## BOQ\_ANNEXURE\_2

## **PROJECT SPECIFIC DRAWING & DOCUMENT LIST**

DRG / DOC TITLE NTPC DRG / DOC NO.						
	9587-001-230-PVC-F-00	047A				
BHEL DRG/ DOC NO.	TB-423-316-005					
Revision	0					
Reviewed By	NTPC					
NTPC COMMENTS REF:	CC-ENGG-9587-001-230-PVC-F-0047A, DTD. 20.05.2024					
1 1 1 1 1 1 1 1 1 1 1 1 1 1 1 1 1 1 1	400kV AIS SWITCHYARD					
Page No. / Clause No. / Sheet No.	NTPC Observations / Comments dtd. 20.05.2024	BHEL Reply dtd 07.10.2024

2 X 800 MW NTPC LARA STPS STAGE-II EPC

400 KV - EARTHING LAYOUT

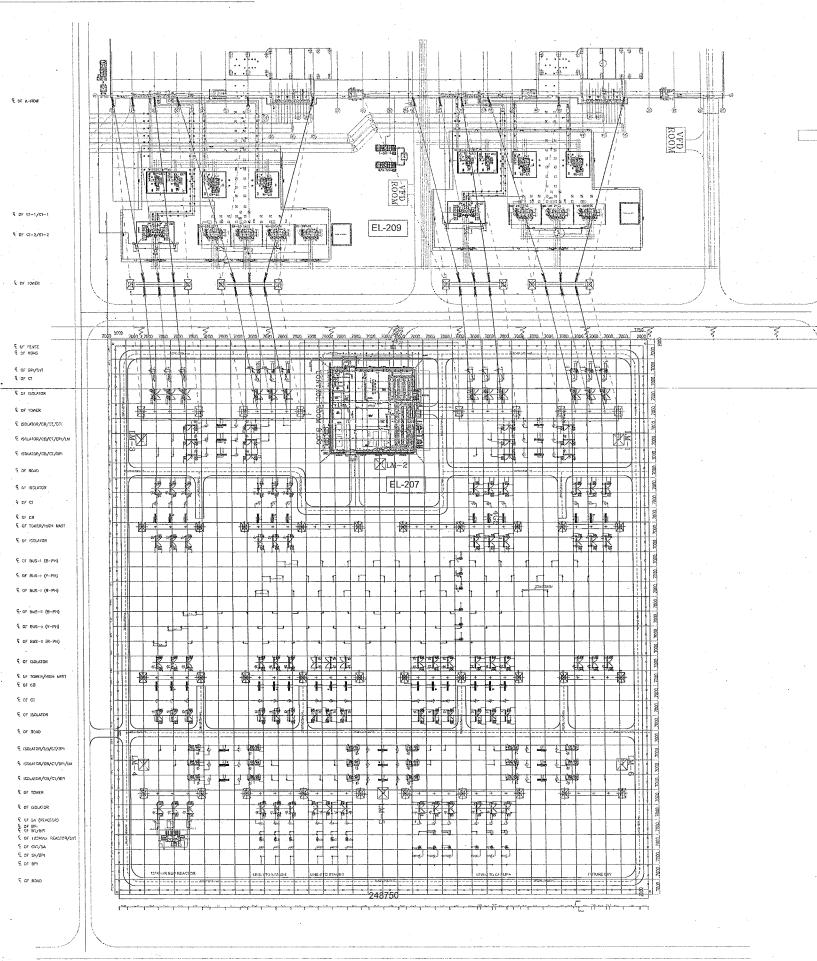
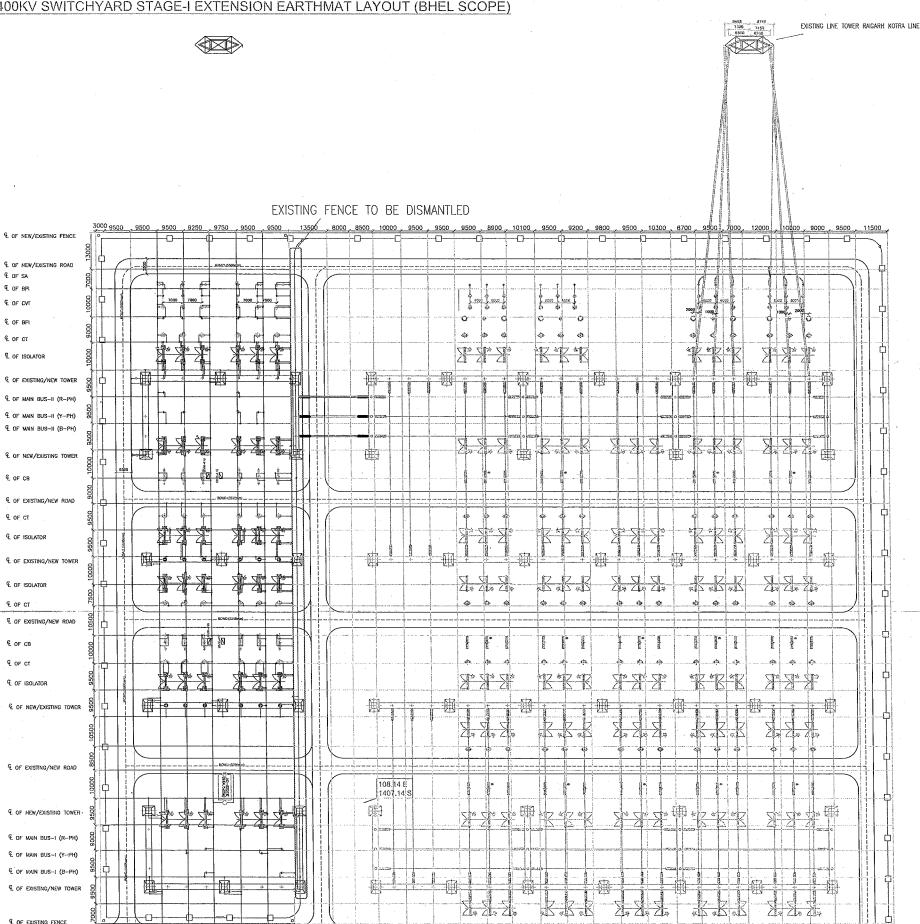
-3.24.1		COMMENT RESOLUTION SHEET For Rev 01					
	DRG / DOC TITLE	400 kV - Earthing Laye	out				
	NTPC DRG / DOC NO.	9587-001-230-PVE-F-0	0034				
	BHEL DRG/ DOC NO.	TB-423-509-001, Rev.00					
	Revision	0					
	Reviewed Bÿ	NTPC					
	NTPC COMMENTS REF:	CC-ENGG-9587-001-230-PVE-F-0034	4, DTD. 28.09.2024				
		400kV AIS SWITCHYARD					
SR. No.	Page No. / Clause No. / Sheet No.	NTPC Observations / Comments dtd 28.09.2024	BHEL Reply dtd 18.10.2024				
1	Sheet-1 of 2	Please check coordinate w.r.t layout drawing	The coordinate are being removed here. Same shall be referred from Layout drawing & Civil foundation drawing for Control room building.				
2	Sheet 1 of 2	Indicate no of Rod electrodes in table.	Same is already there in the table of rod electrodes. Remark column added for applicability of test pit.				
3	Sheet 1 of 2	Indicate no of Pipe electrodes in table.	The same is already available in the table below qty of rod electrodes
